# SERVICE BULLETIN

**PRODUCT:** Computer Monitor  
**BULLETIN:** Monitor 95-002  
**MODEL:** CSR5987

**SUBJECT:** CRT Substitution

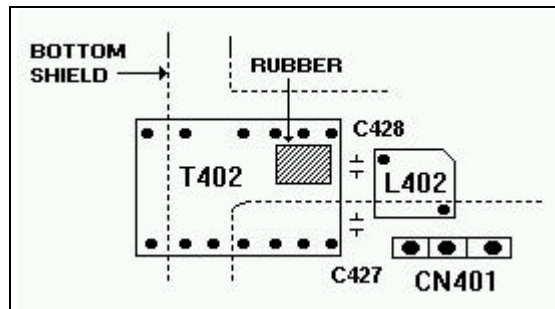
**BACKGROUND:** A whistling sound is created from harmonic noise generated between T402, L402, and the main PCB near the Flyback Transformer.

**SOLUTION:** Add a piece of rubber to insulate the main PCB solder side from the bottom metal shield. See Illustration below showing the section of the PCB where the rubber will be located.

Part No.	Description
BH61-30303A	RUBBER

**Figure 1**

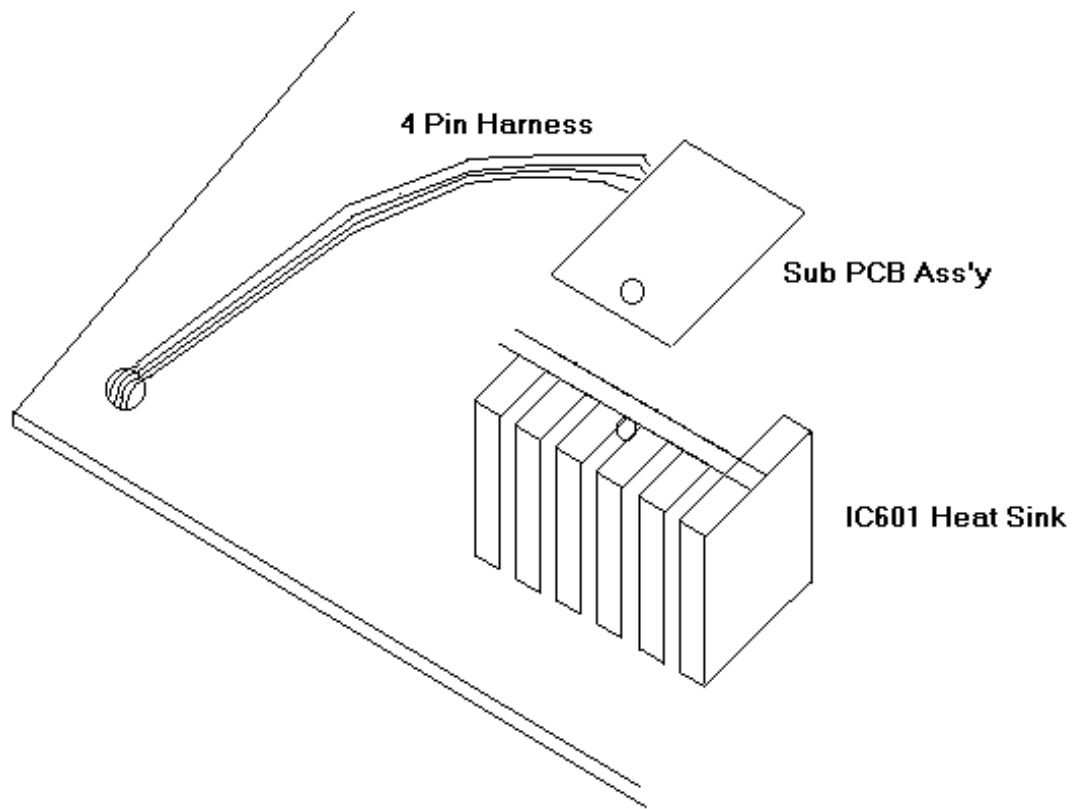
**BACKGROUND:** Q407 fails due to a transient pulse and current when mode switching from DOS to Windows. This occurs with a Matrox video card installed in the computer.

**SOLUTION:** Add a sub-PCB assembly as in figures 1 and 2 and a snubbing circuit for the horizontal output as in figure 3.

ORIGINAL			NEW	
Location No.	Part No.	Description	Part No.	Description
NA	NA	NA	BH92-50106J	SUB-PCB ASSEMBLY
NA	NA	NA	BH39-40355S	4 PIN CBF-HARNESS
NA	NA	NA	6003-000129	TAPTITE SCREW
NA	NA	NA	0401-000005	1N4148 DIODE
NA	NA	NA	0402-000012	UF4007 DIODE
NA	NA	NA	2003-000009	220 OMHS, 1 WATT
